RS-15-097

Nine Mile Point Nuclear Station, Unit 1
Renewed Facility Operating License No. DPR-63
NRC Docket No. 50-220

Subject: Report of Full Compliance with March 12, 2012 Commission Order Modifying Licenses with Regard to Reliable Spent Fuel Pool Instrumentation (Order Number EA-12-051)

NMP1 SPENT FUEL POOL PLAN VIEW

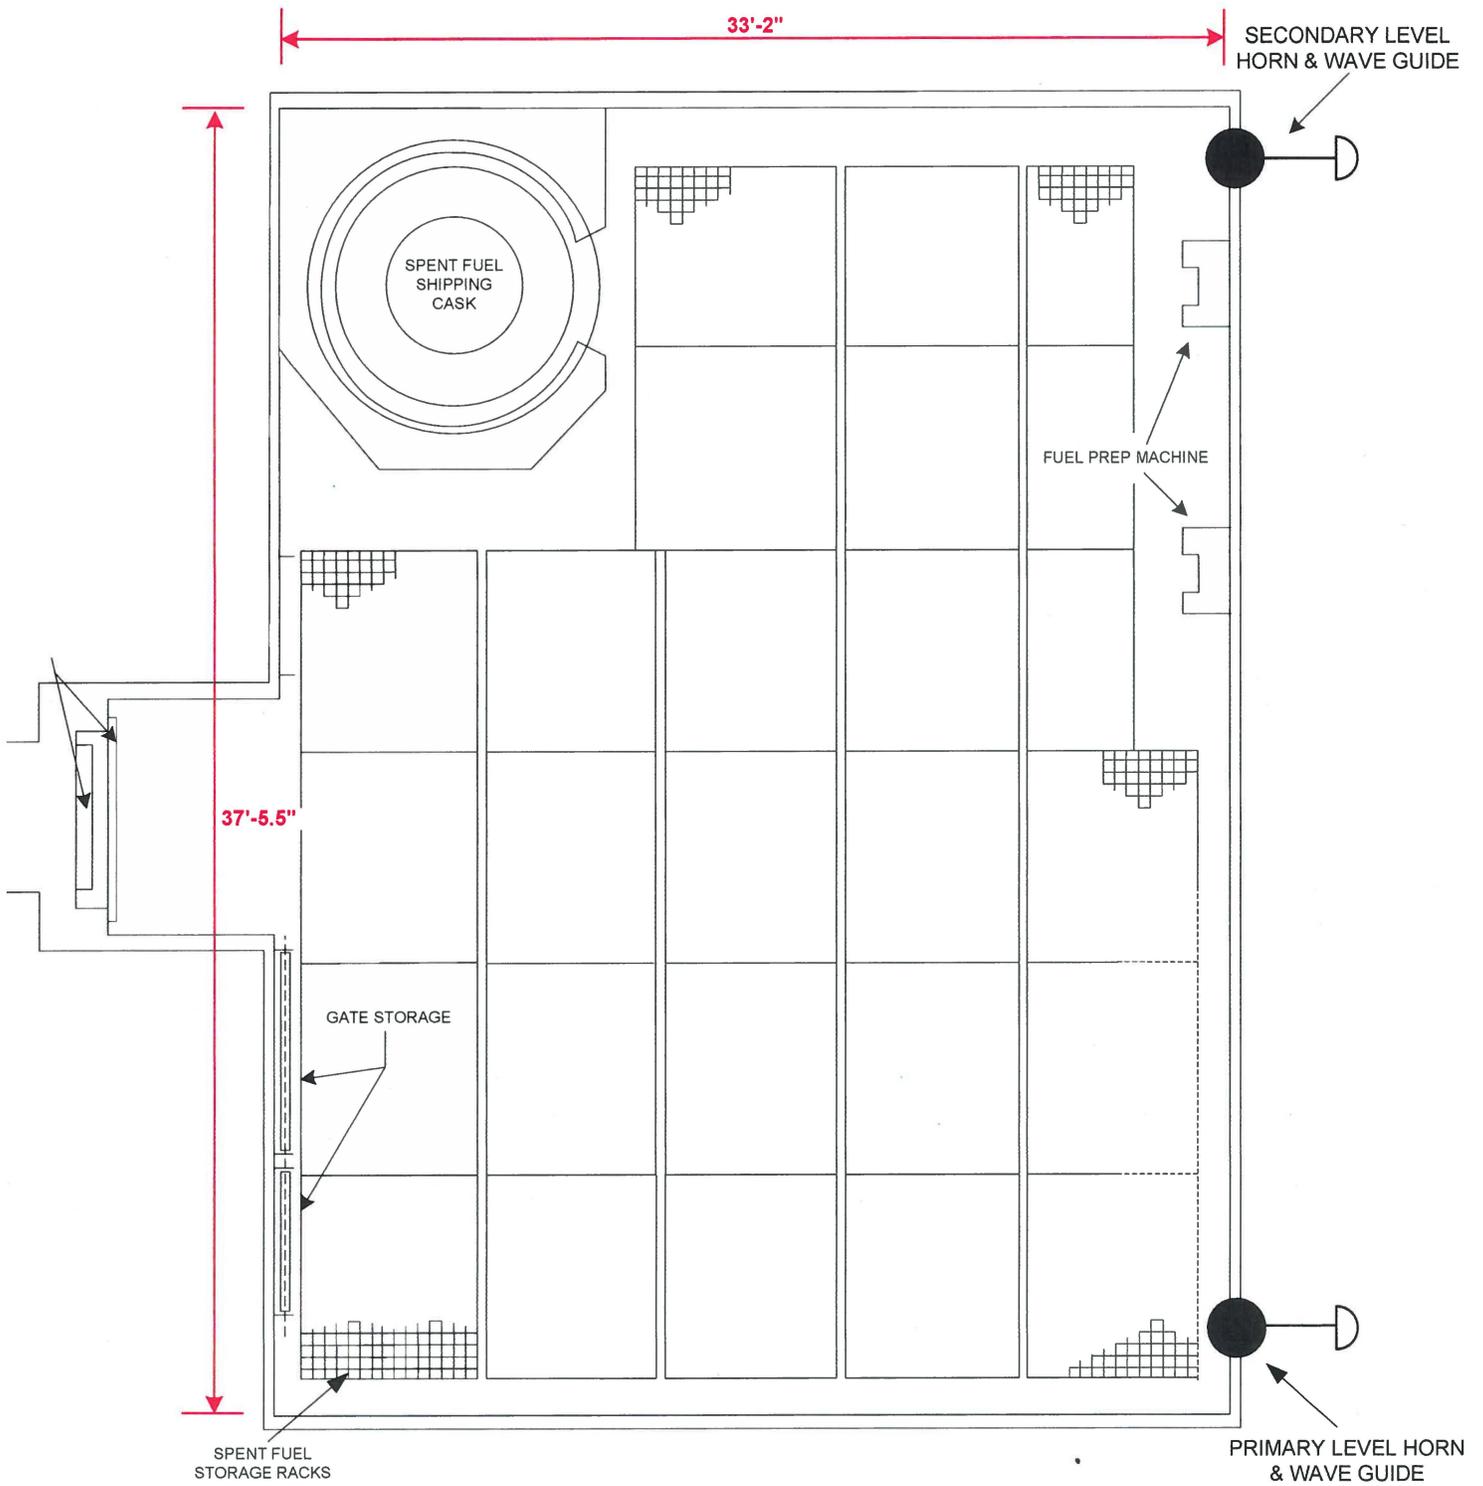
Item	Description	Reference
ISE RAI No. 2 – Provide a final labeled sketch or marked-up plant drawing of the plan view of the SFP, depicting the SFP inside dimensions, the planned locations/placement of the primary and back-up SFP level sensor, and the proposed routing of the cables that will extend from these sensors toward the location of the read-out/display device.	Refer to enclosed drawings (Figures 1-4) for the SFP and associated SFP Level Sensors and waveguide tubing route. The NMP1 Spent Fuel Pool is 33'-2" wide by 37'-5.5" long and 39'-2" deep. The primary level sensor will be mounted on the east side of the southeast corner of the spent fuel pool on elevation 340' in the Reactor Building. The back-up sensor (redundant) will be mounted on the east side of the north east corner of the spent fuel pool on elevation 340' in the Reactor Building. Both Primary	Complete

<p>and Backup sensor tubing will proceed east for a short distance before each enter a new core bore through the refuel floor concrete slab. The sensor tubing will travel further east and vertically downward where the sensor electronics are mounted on the east wall of the Reactor Building (north and south for the respective level sensor) on the elevation 318' one level below the Refueling Floor. Local level indication is provided next to the sensor electronics at this location. From this point, the instrument cables are routed in separate dedicated conduit within the Reactor Building down to elevation 261' and 250'. From there the cables are routed in separate cable tray through the Turbine Building and into the Auxiliary Control Room for primary and backup SFP level readout capability. The Auxiliary Control Room is located one elevation below and is accessible from the Main Control Room.</p>
